Proposed Temporary Green Fuel Station for Electric Taxi and Shop and Services (Motor Vehicle Showroom and Refreshment Kiosk) with Ancillary Facilities and Associated Filling of Land for a Period of 3 Years at Lot 91RP(Part) in D.D. 81, Man Uk Pin, N.T.
(Application No. A/NE-MUP/239)

Geotechnical Planning Review Report (GPRR)

Supplementary Sheet to GPRR Section 2(b) – Natural Terrain

Annex 2: Responses to Departmental Comments (Planning Application No. A/NE-MUP/239) (7 October, 2026)

DRAWING No.
GPRR PLAN

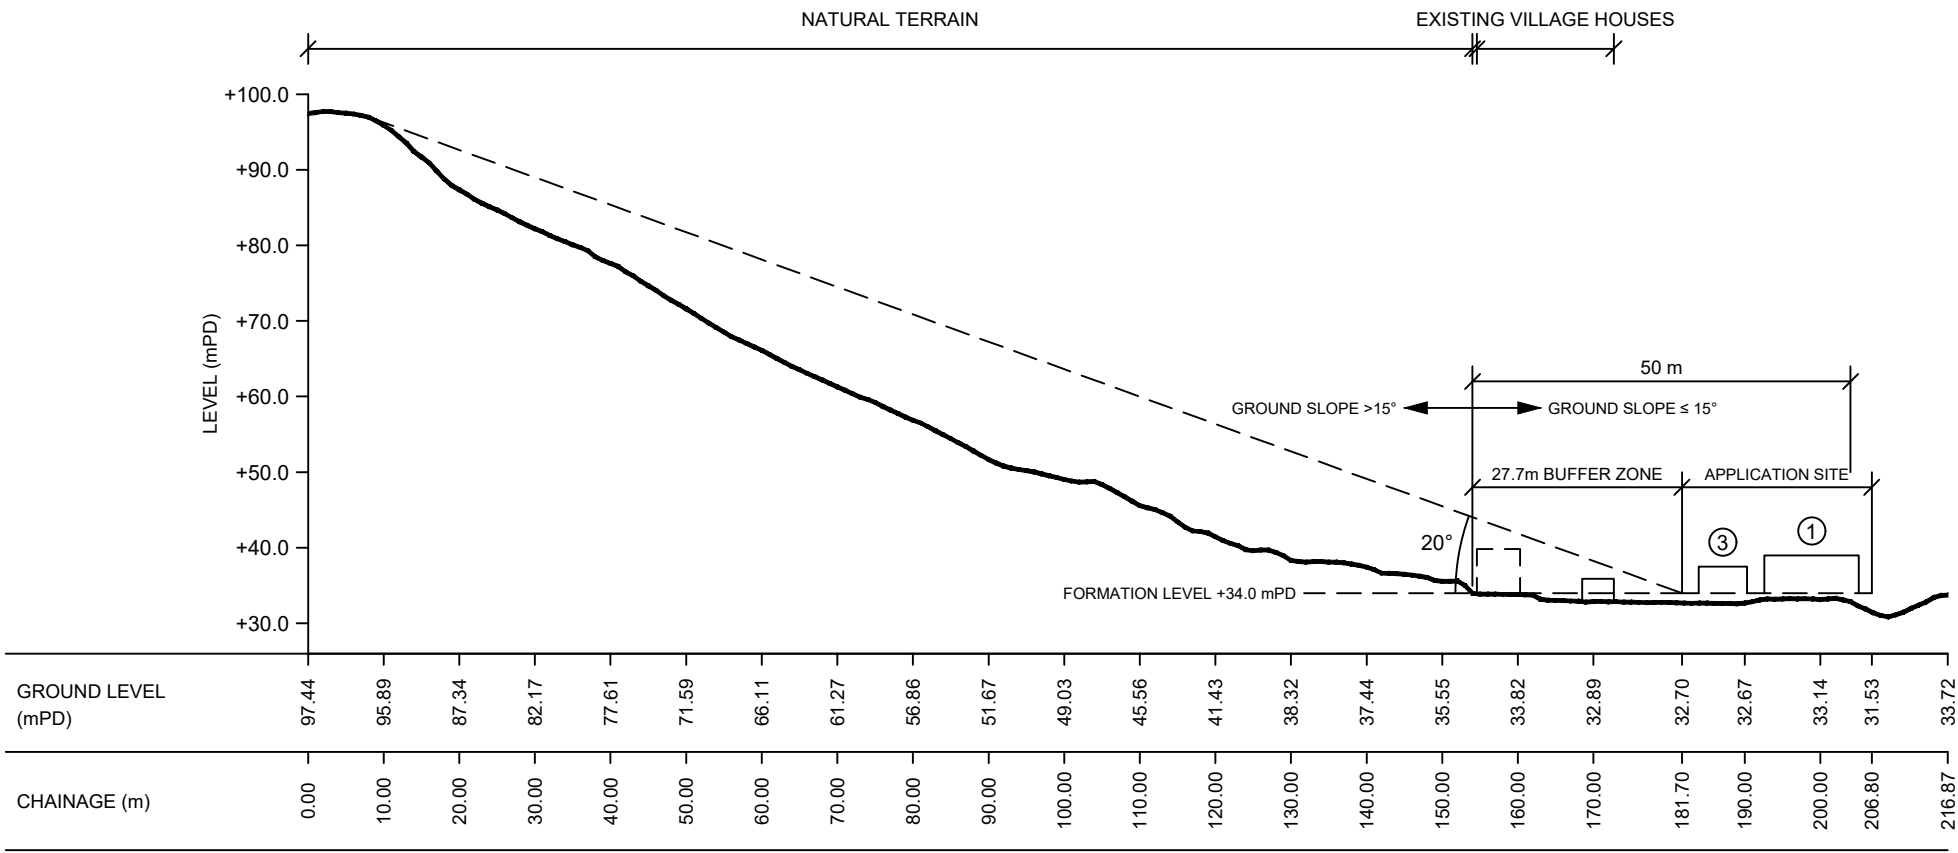
The application site is overlooked by natural terrain on its north and south sides. Based on topographic map No. 3-NE-21A from the Survey and Mapping Office of the Lands Department and the Digital Terrain Model from the 2020 LiDAR Survey, tile 3NE21A, obtained from the CSDI Portal, the catchment area are described below and presented in Drawing No. GPRR PLAN, with relevant sections of the catchment presented in Drawing No. GPRR SECTION.

The application site is separated from the natural terrain by a buffer zone on both the northern and the southern side. On the north side, the buffer zone is occupied by existing village houses and the village access road. On the south side, it is occupied by Sha Tau Kok Road and the existing channel. These existing features would intercept debris before it reaches the application site. Accordingly, there is no credible debris flow path from the natural terrain to the application site, and the Alert Criteria of GEO Report No. 138 are not met. It is therefore concluded that a natural terrain hazard study is not required for the proposed temporary development.

DRAWING No.
GPRR SECTION

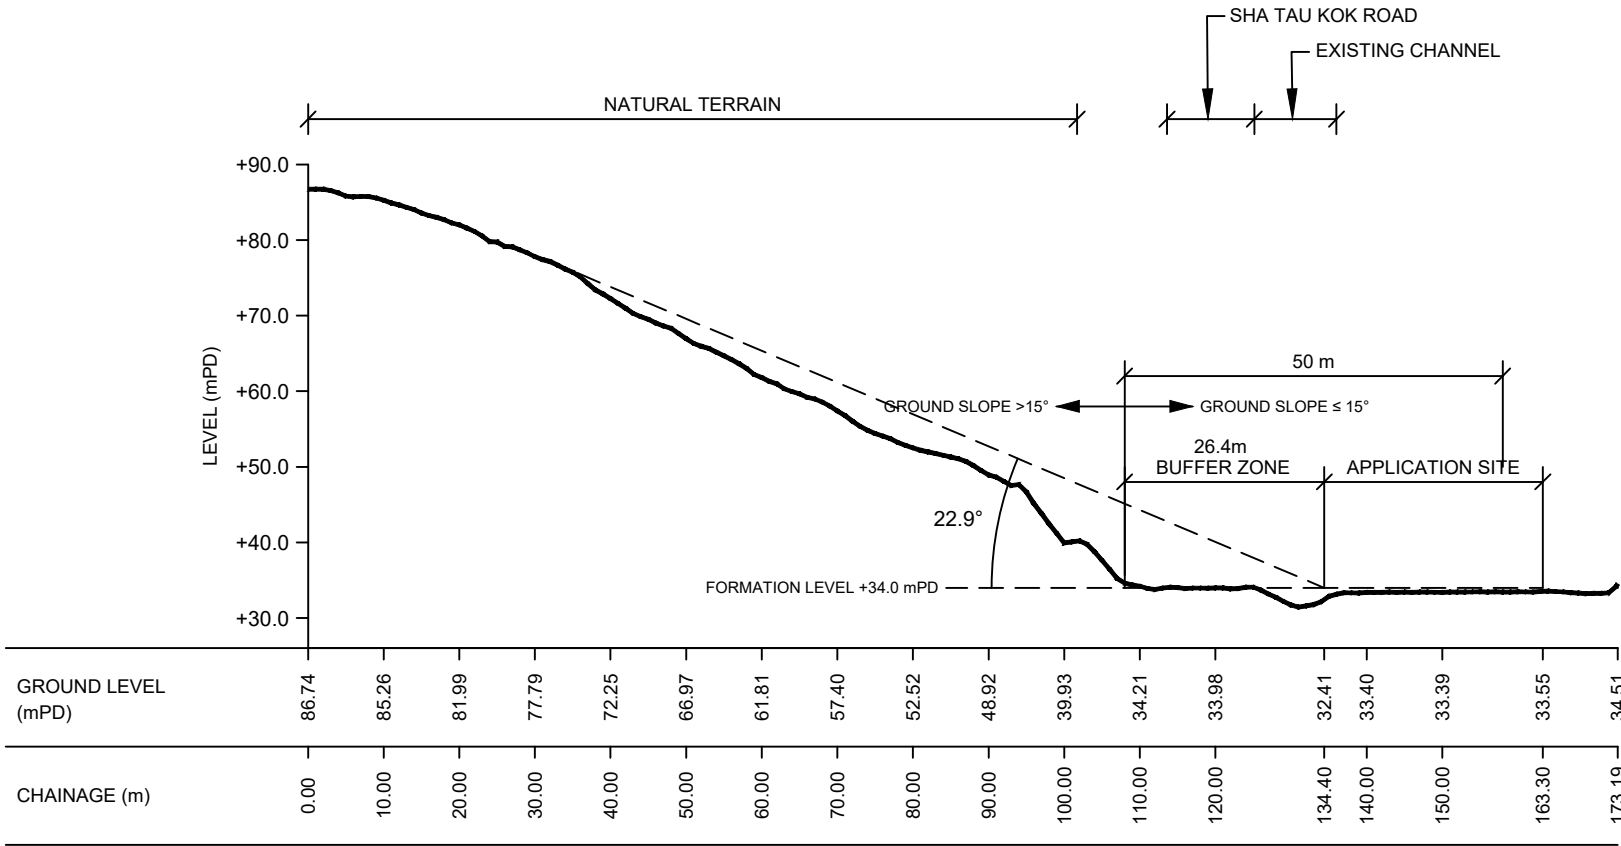
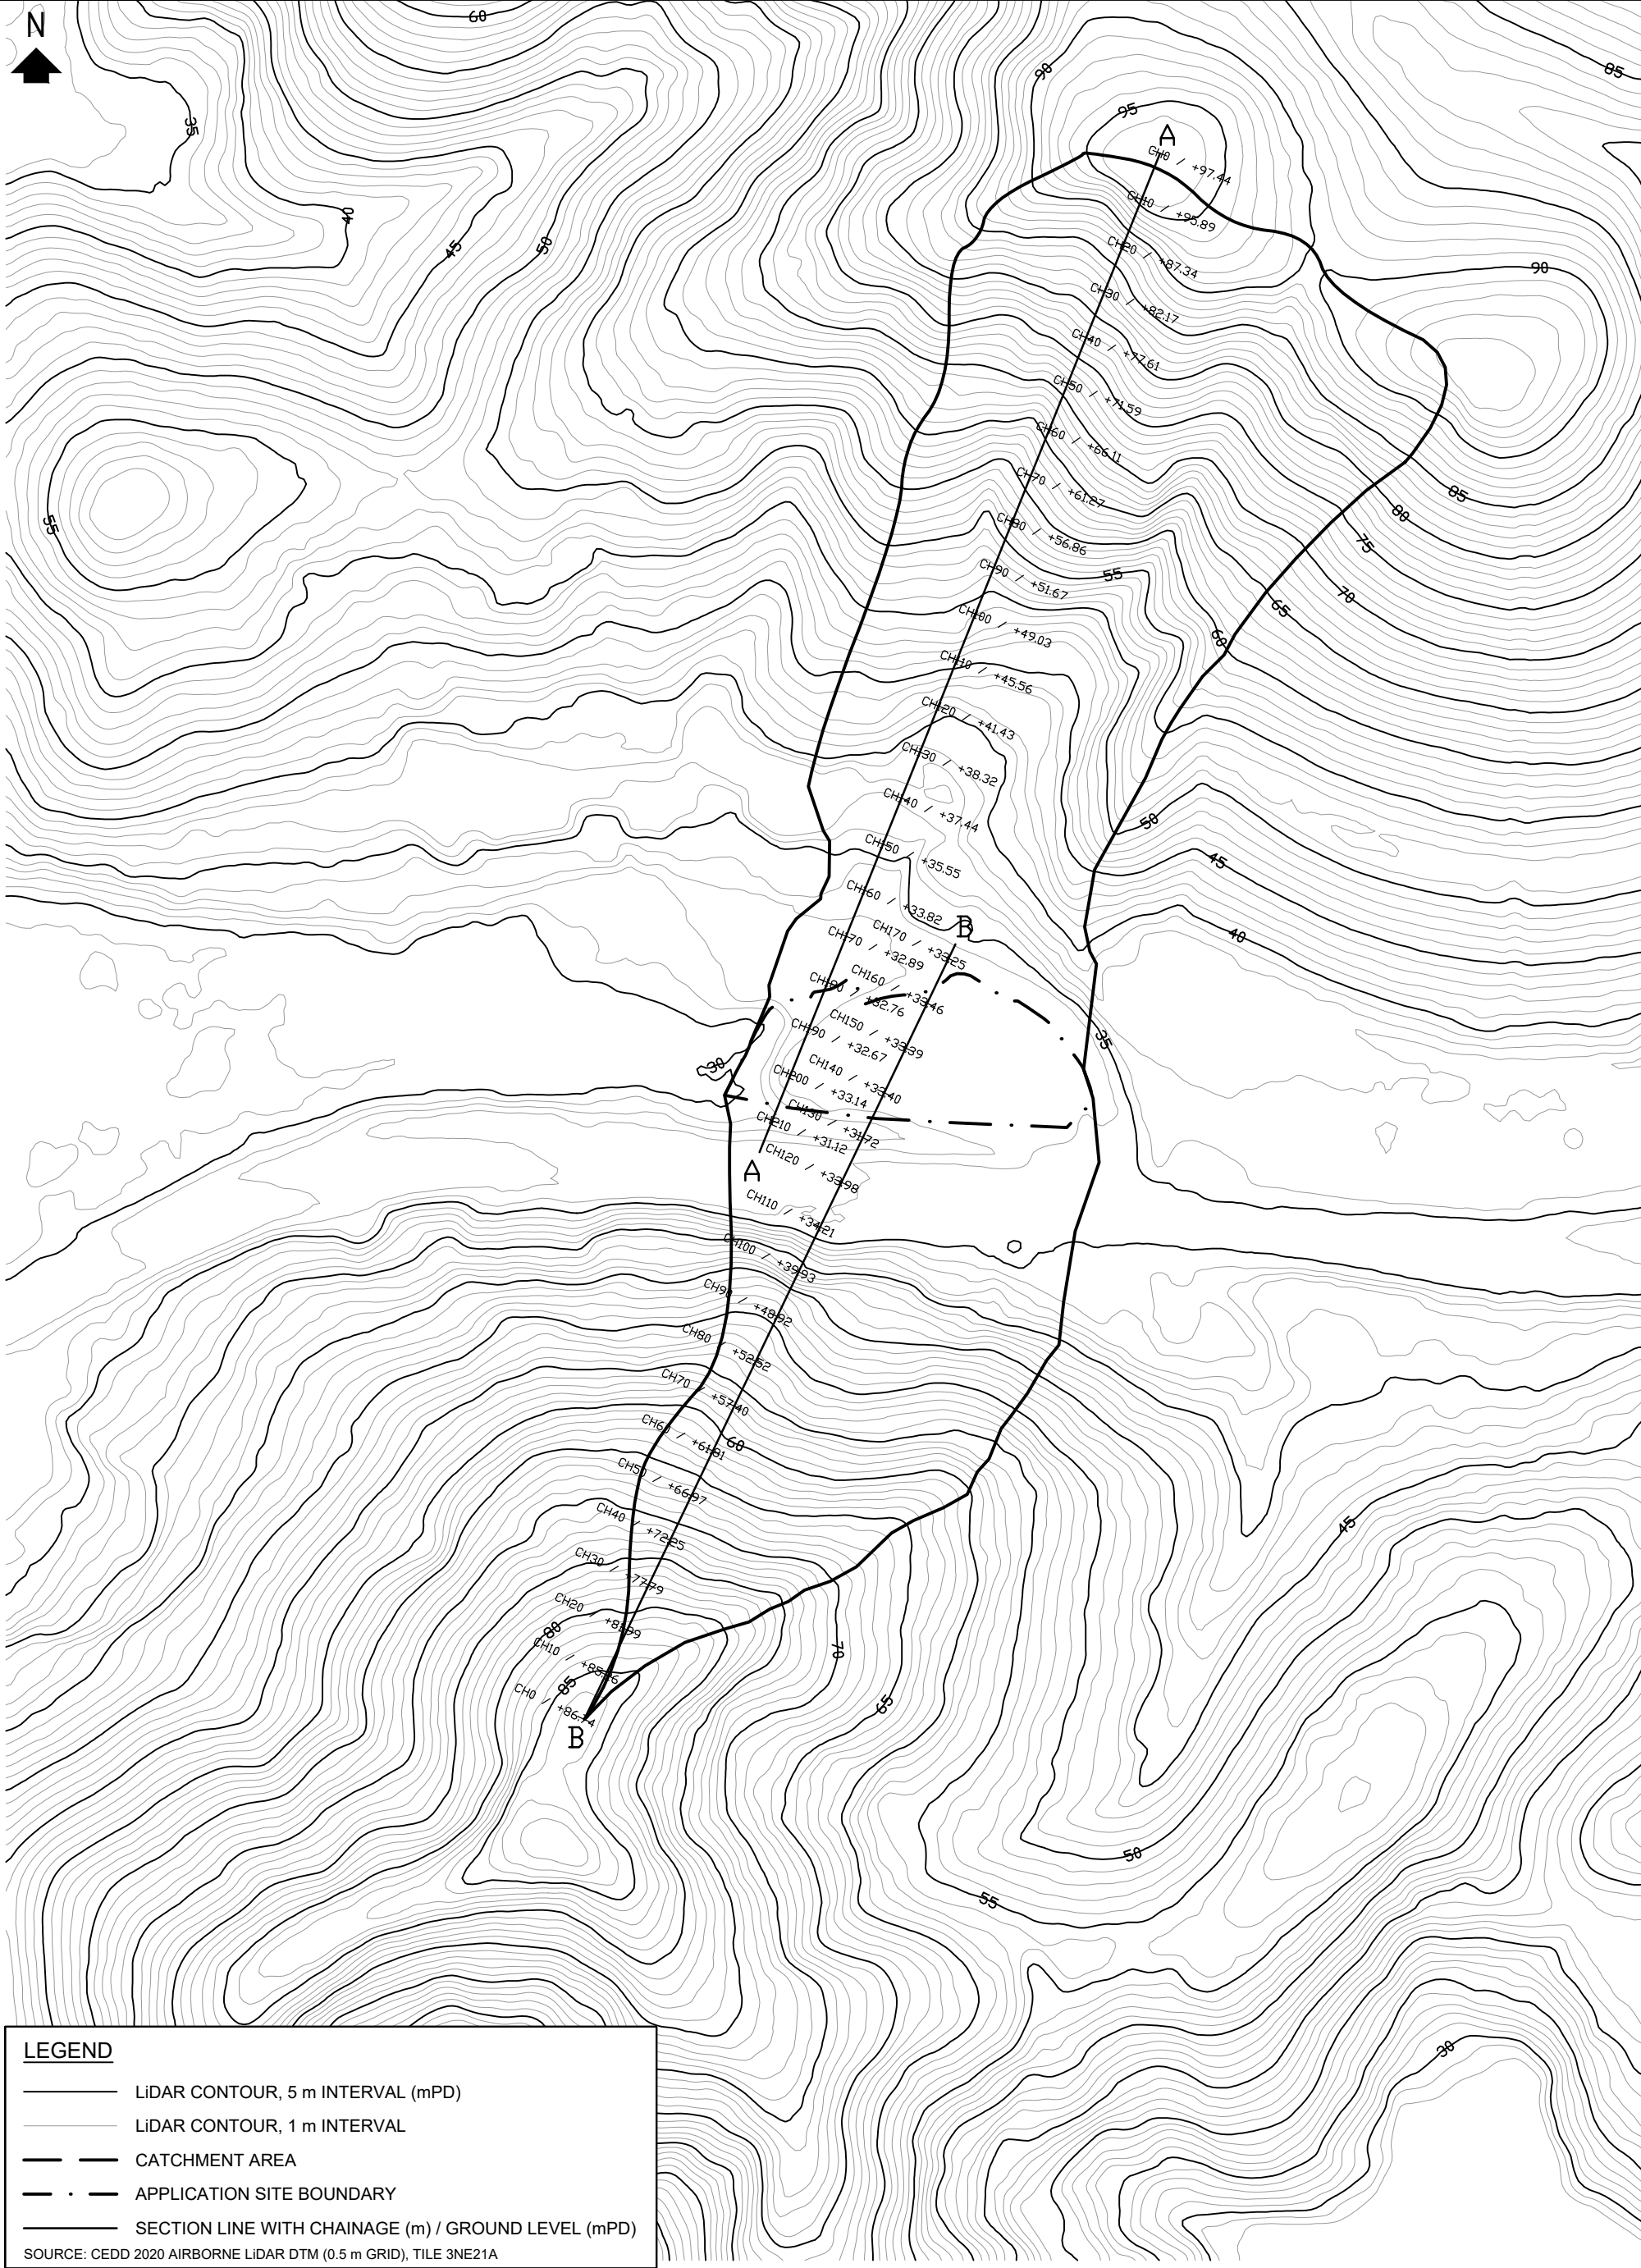
The natural terrain on the north side rises from about +34 mPD at its toe to about +97 mPD. The angular elevation from the application site is 20°. There is a buffer zone of about 28 m between the toe of the hillside and the application site. The ground in this buffer zone is nearly level, falling from about +34 mPD to about +32.7 mPD. It is occupied by existing village houses of one to two storeys with fence walls, and by the village access road. The debris flow path and the buffer zone are marked on **Figure 1**. These existing structures shield off the application site from the catchment. Debris from the hillside would deposit on this level ground before reaching the application site. Hence, there is no credible debris flow path from this hillside to the application site.

The natural terrain on the south side rises from about +34 mPD at its toe to about +87 mPD, with Feature No. 3NE-C/C 201 at the toe. The angular elevation from the application site is 22.9° . There is a buffer zone of about 26 m between the toe of the hillside and the application site, as shown in **Figure 2**. Sha Tau Kok Road and an existing channel lie within this buffer zone. The road is at about +34 mPD. The channel is about 12 m wide and its bottom is at about +31.4 mPD, which is about 2.5 m lower than both the road and the proposed site level, as shown in **Figure 3**. The channel provides a low and gentle area where debris would slow down and deposit. It would act in a similar way to a debris retention basin as described in Section 5.3.2 of GEO Report No. 138. The road and the channel together form a buffer area in line with Section 5.2(c). Debris from the hillside would therefore be caught before reaching the application site. Hence, there is no credible debris flow path from this hillside to the application site.

SECTION	ANGULAR ELEVATION OF NATURAL TERRAIN FROM FORMATION LEVEL +34.0 mPD	GROUND SLOPING >15° WITHIN 50 m UPSLOPE OF SITE	CREDIBLE DEBRIS FLOW PATH TO THE SITE?	ALERT CRITERIA MET?
A-A	YES (20°)	YES (TOE 27.7 m FROM SITE)	NOT CREDIBLE (REFER TO SUPPLEMENTARY SHEET, PARA. 3)	NO (DEBRIS NOT EXPECTED TO REACH THE SITE)
B-B	YES (22.9°)	YES (TOE 26.4 m FROM SITE)	NOT CREDIBLE (REFER TO SUPPLEMENTARY SHEET, PARA. 4)	NO (DEBRIS NOT EXPECTED TO REACH THE SITE)
